REMARKS

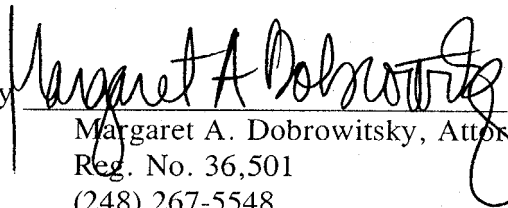
Drawing FIG. 7 is amended for consistency with references to the figure on pages 3 and 5 of the specification which describe a five phase winding without reference to A and B parts. The drawing is amended to delete references to a second set of winding parts. FIG. 11 and the accompanying description on page 6 of the specification describe the alternative of a winding having A and B parts.
